Addendum Number Four

EMS Post #1

RFB Bid Number: 26-0035, Sedgwick County, Kansas

Issued: September 10, 2026

A FLOOR PLAN
SCALE: 1/4" = 1'-0"

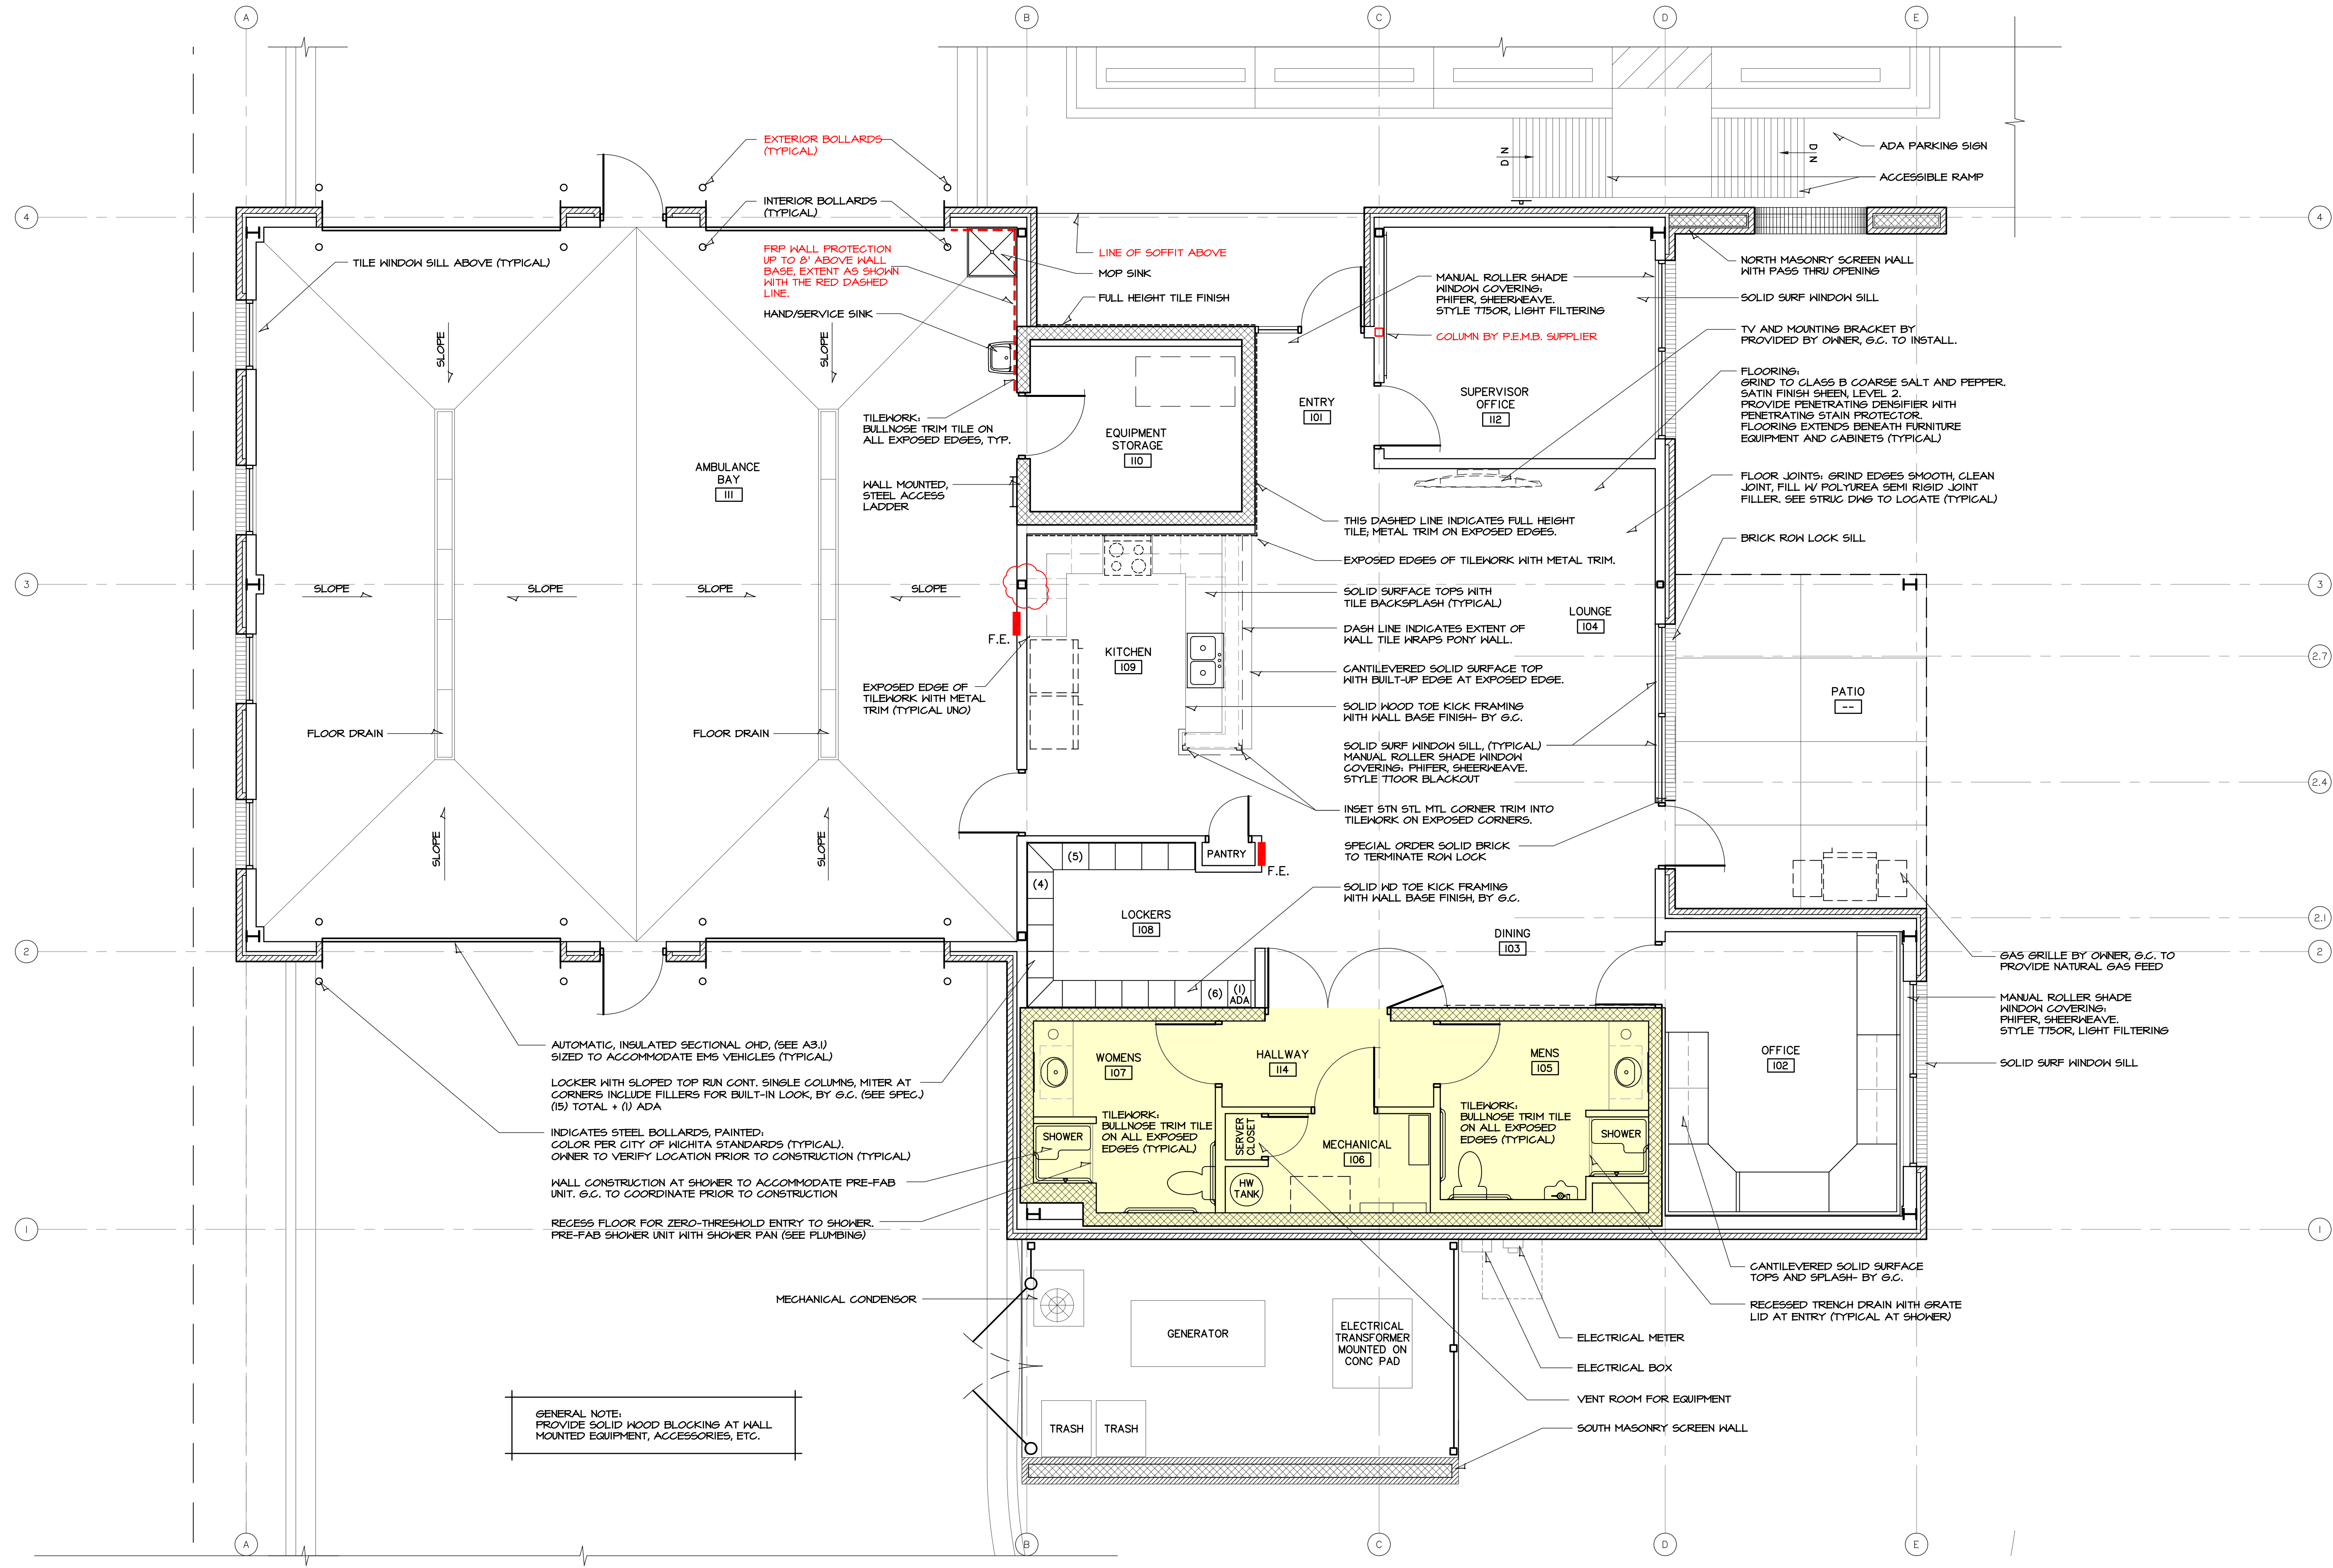
- 1.3 Column 3- B
This square column is not shown at the grid intersection 3- B. The column shall be moved to this grid intersection.
- 1.4 Grease Interceptor
The 500-gallon, Grease Interceptor, shall be equal to GI-500 as manufactured by Clutter-Case, Inc.

- 3.1 Sheet A1.1
This sheet is being reissued to illustrate the column changes and extent of FRP wall protection in the Ambulance Bay.
- 3.2 Sheet A1.2
This sheet is being re-issued with this addendum.
